ADDENDUM NO. ADDM-01

to the
Bidding Documents
30 January 2026

PICTURED ROCKS NATIONAL LAKESHORE TRAIL REHABILITATION MUNISING FALLS
Munising, MI
PMIS No. 226930

PHOTOGRAPHS TAKEN SEPTEMBER 2025

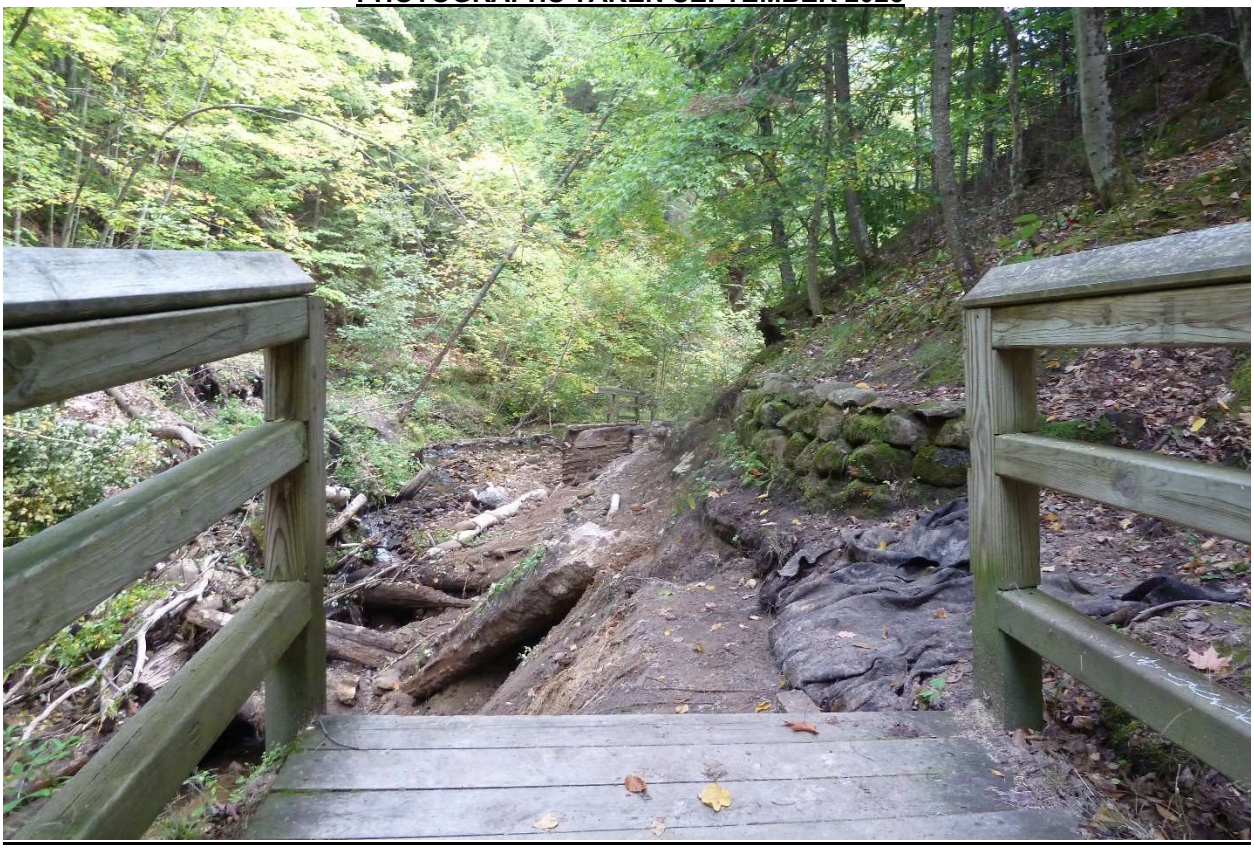
In April 2025, the project site experienced a high impact rain induced flood event at the peak of snowmelt which undermined and fully displaced an approximately 75-foot reach of wood cribwall, asphalt trail, and wood handrail rendering it impassible. The trail was immediately closed to the public and shall remain as such until the completion of the scope of work under this contract. Existing topography and geology previously concealed by the constructed trail and crib wall has been exposed.

Park staff, having obtained approval from the US Corps of Engineers, have extracted and stockpiled the debris from the failure arranged by material (asphalt, limestone rip-rap, wood timber and dimensional lumber railing) adjacent to the trail at the eastern limits of the impacted reach. Refer to photographs as provided within this addendum.

The Contractor's scope of work for removals remains as called out in the Construction Documents, to remove, haul off site, and lawfully dispose of material. The state of the material being stockpiled rather than in their original constructed condition for this 75-foot reach is modified by this addendum. This event of failed trail segment does not alter the engineering of the new elevated walkway as detailed and specified in these Construction Documents.

SUB SHEET NO. 01
G2.0

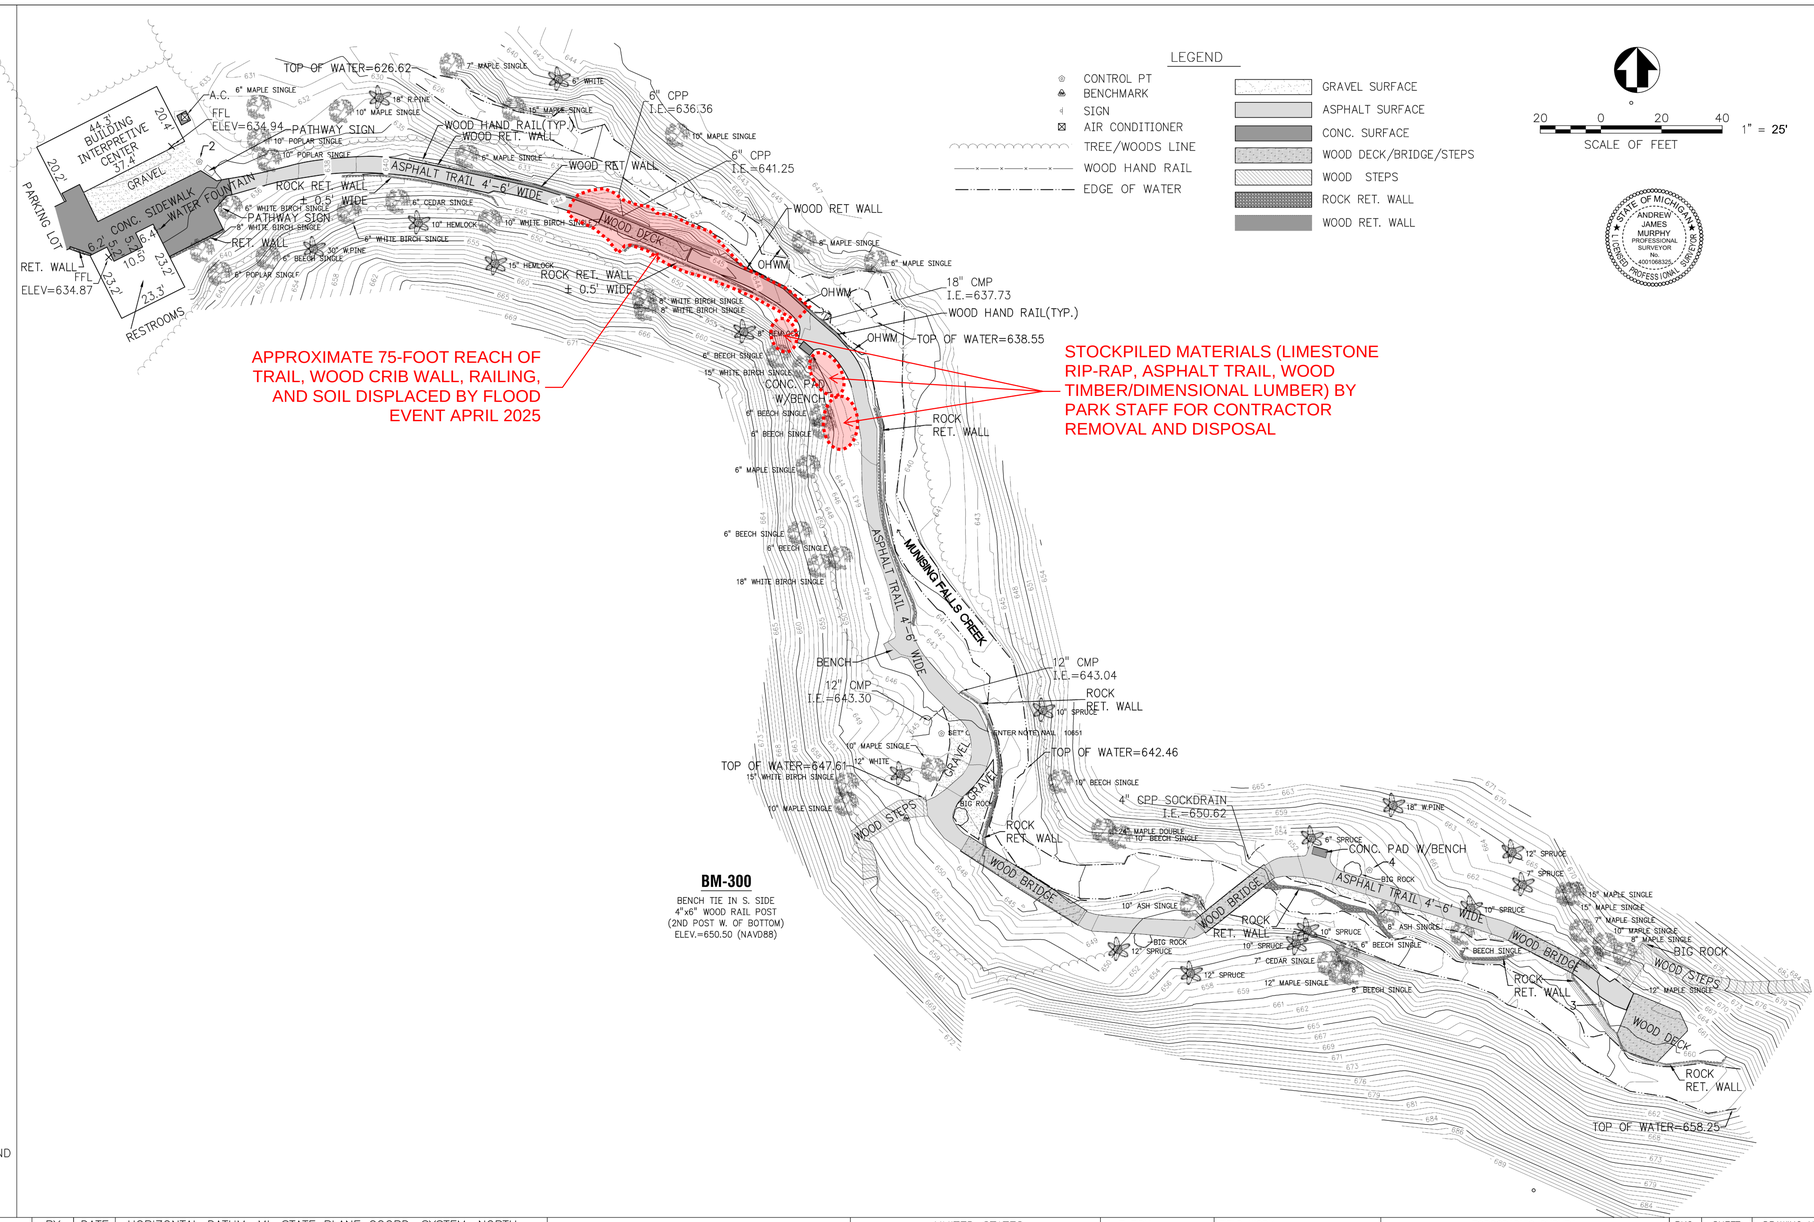
ITEM NO. G-2 SHEET 01 G2.0 SITE SURVEY

a. Replace sheet with the revised sheet 01 G2.0, SITE SURVEY, provided in this addendum. Revisions indicate approximate limits of flood swept trail and cribwall and stockpiling of clean up debris performed by park staff.

SUB SHEET NO. 01
C2.1

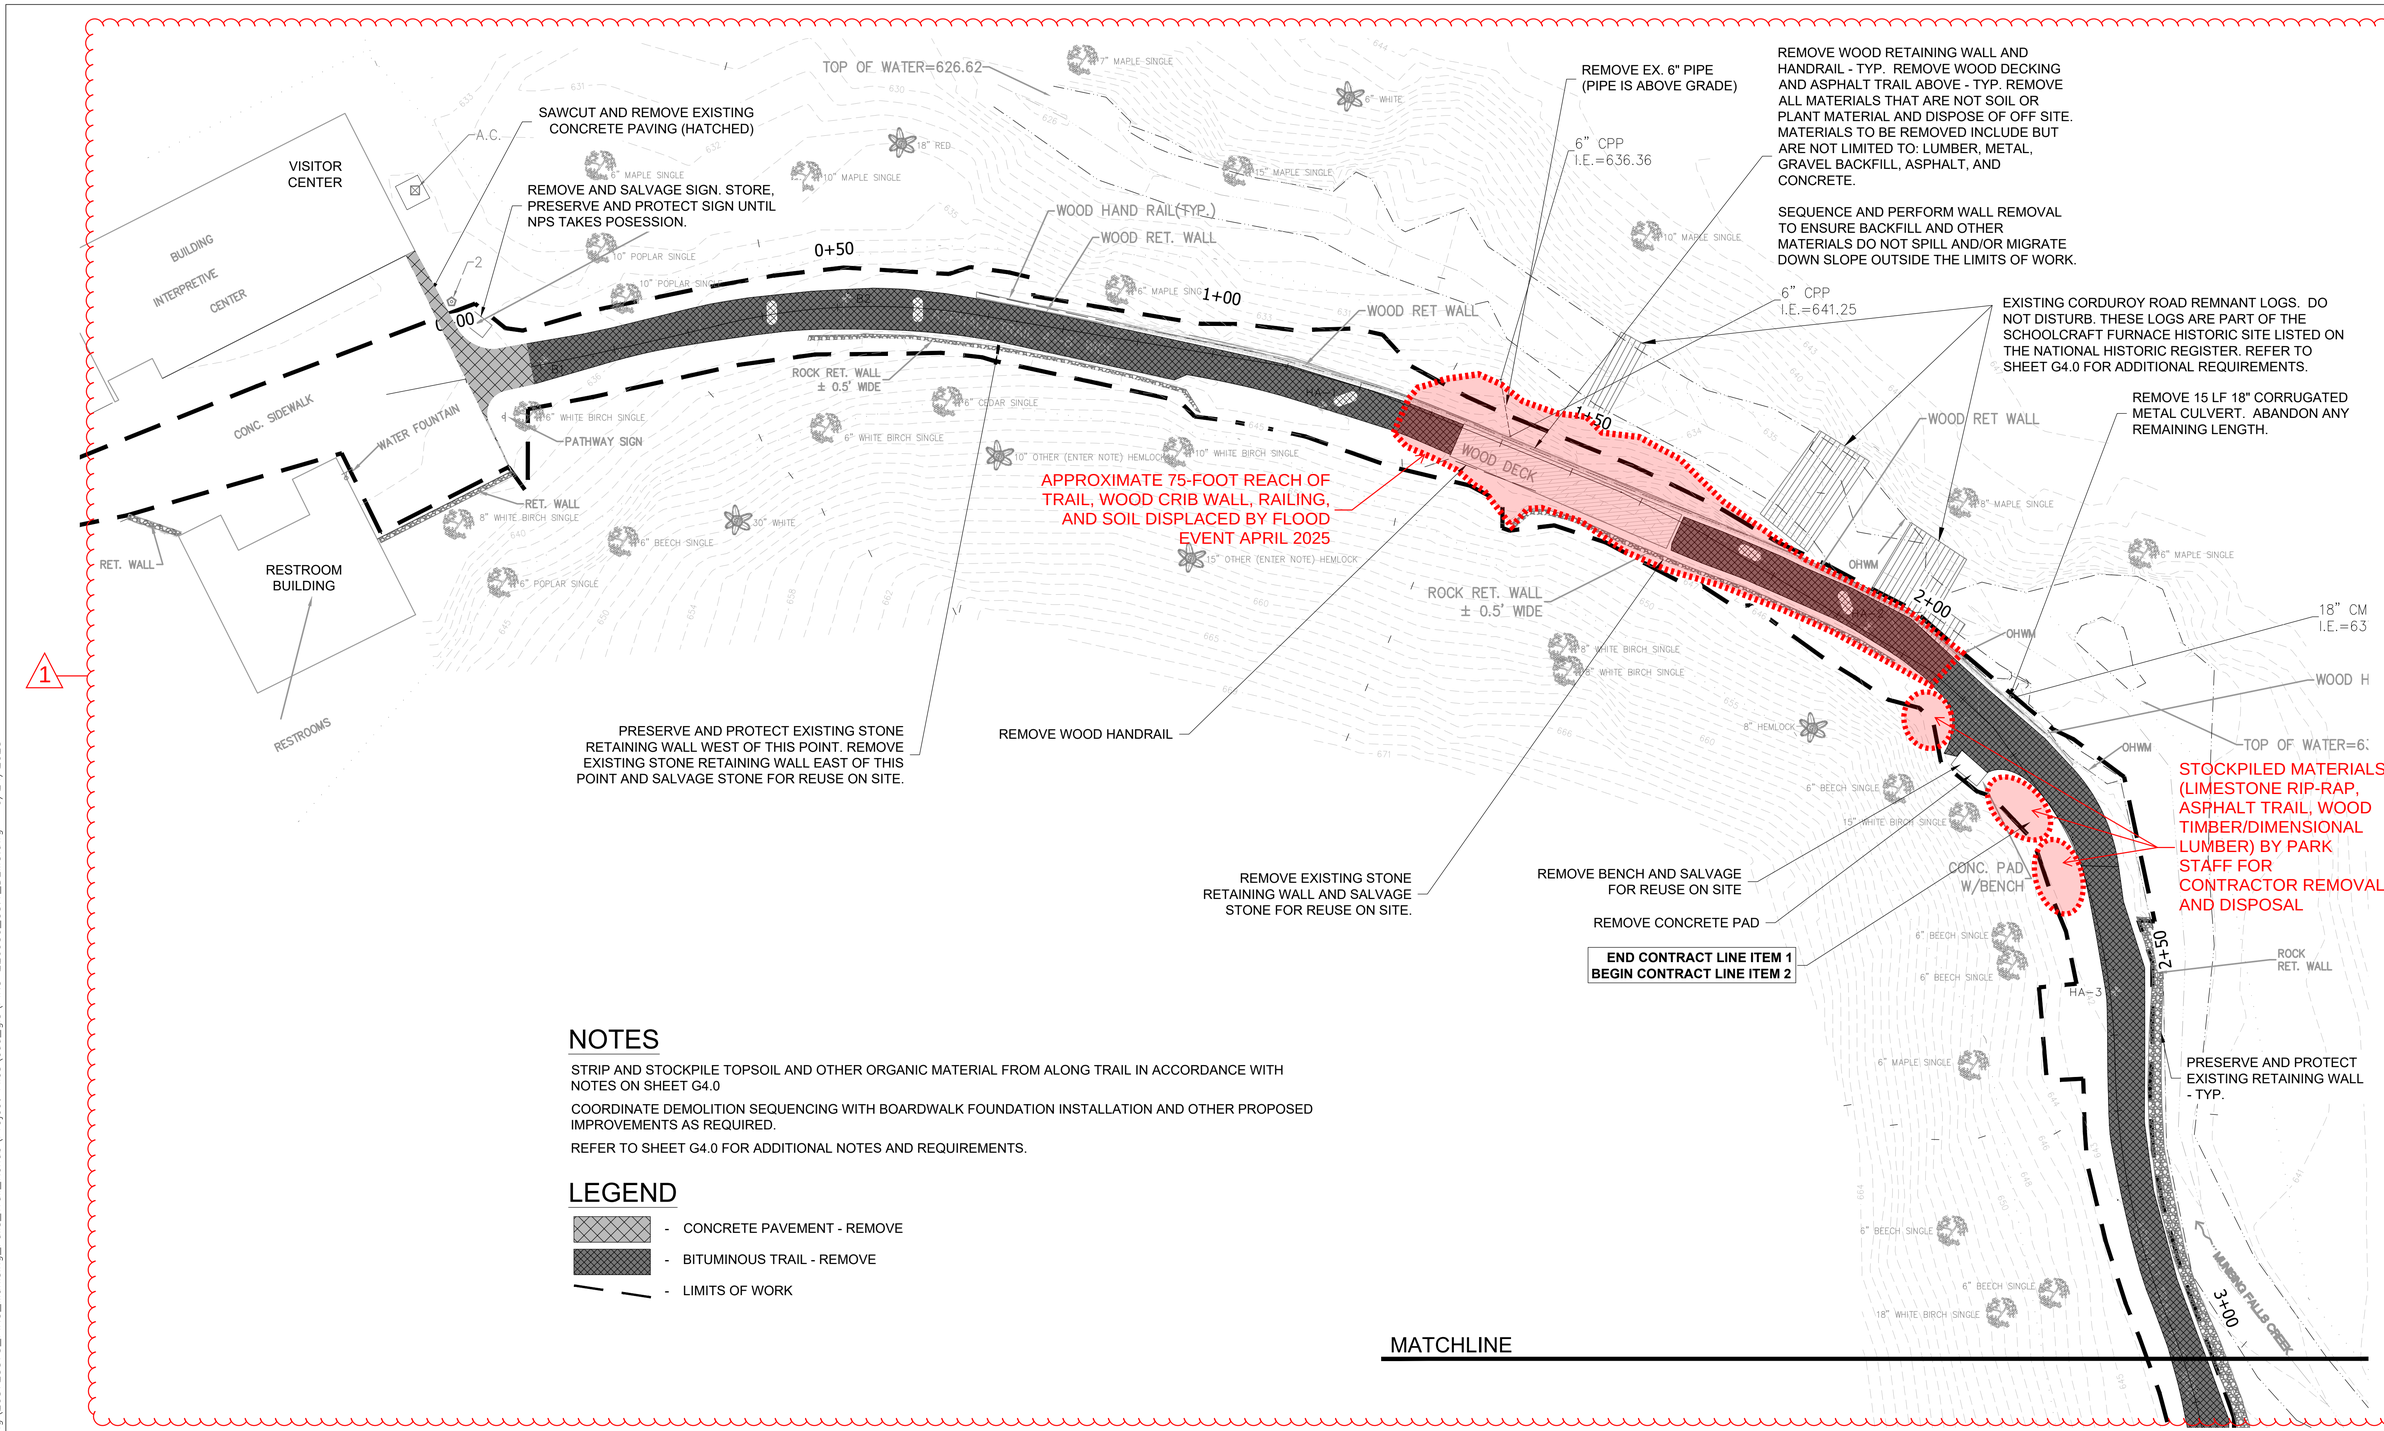
ITEM NO. G-3 SHEET 01 C2.1 EXISTING CONDITIONS AND DEMOLITION PLAN WEST

a. Replace sheet with the revised sheet 01 C2.1, EXISITNG CONDITIONS AND DEMOLITION PLAN WEST, provided in this addendum. Revisions indicate approximate limits of flood swept trail and cribwall and stockpiling of clean up debris performed by park staff.
